NEILL :: CONN  
planned unit  
development  
1/16"=1'-0" 05-23-16

## Neill :: Conn PUD

### Staff Memo Response

**SITE**

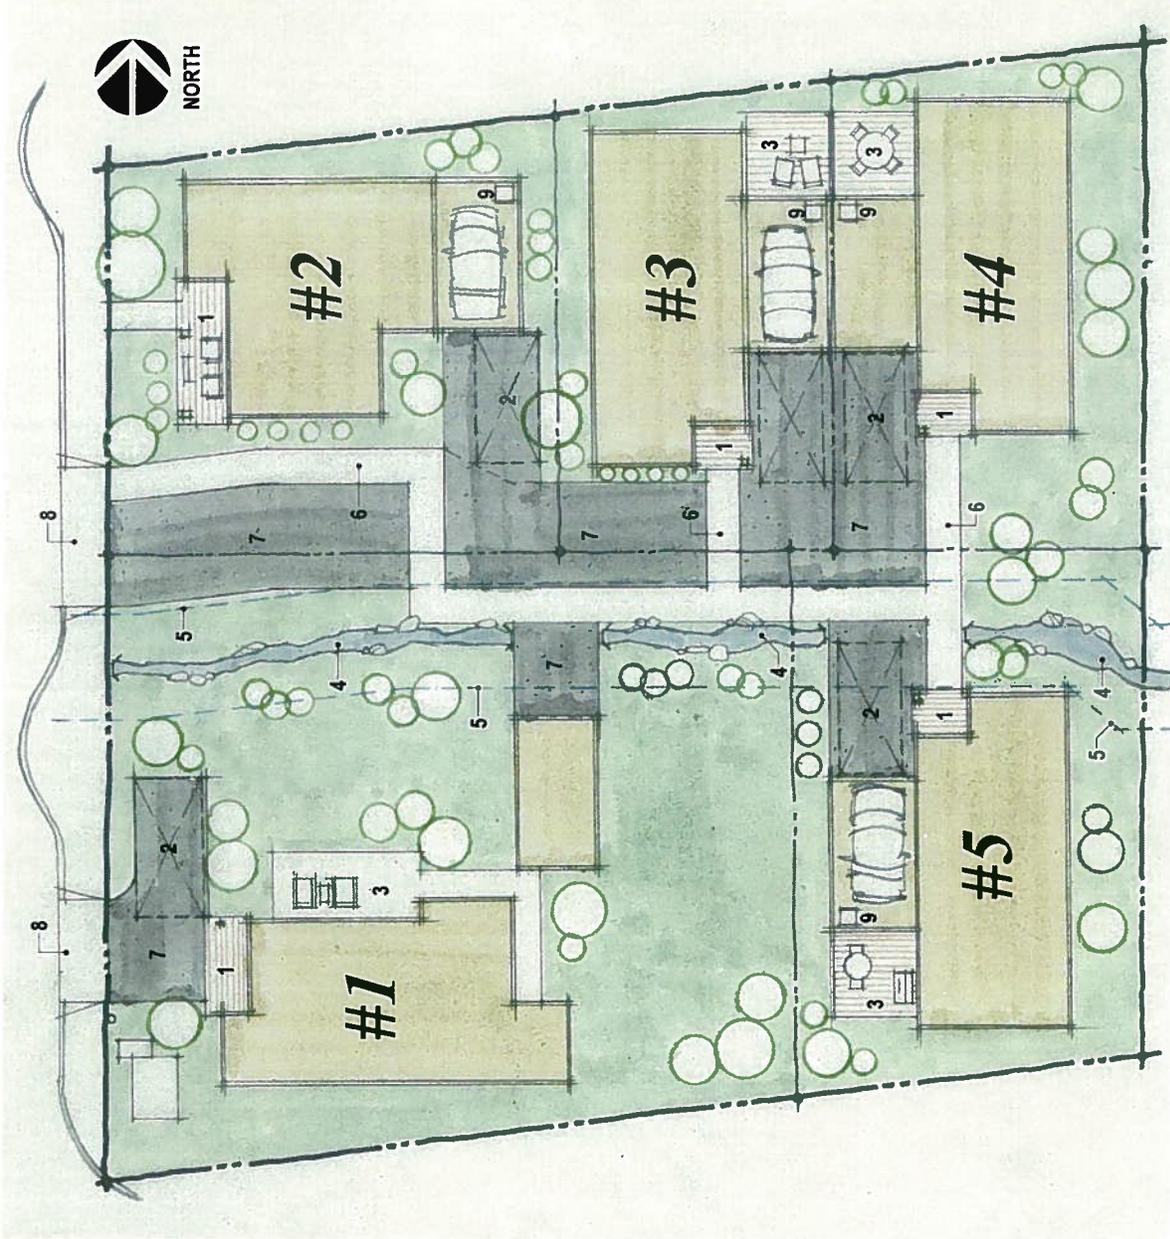
- The access road on the preliminary plans does not meet the code requirement of 20 feet in width. 8-5A-5D and 8-4E-4

- Planned unit development provisions require ten feet between detached residential structures. 8-6B-7

- Parking requirements for single family residential are two spaces per dwelling unit, one in an enclosed garage. One of the front units does not appear to have a garage. 8-4D-5

- How would trash service be handled? 8-4A-5

- At least 10% of a new Planned Unit development is required to be common open space. 8-4L-4

#### **Adjusted Site Plan**

#### **Adjusted Site Plan**

#### **Adjusted Site Plan to show additional space and added garage and space for house #1**

#### **Individual hoppers in garages**

#### **Demonstrated compliance on dimensioned plan per code provision below:**
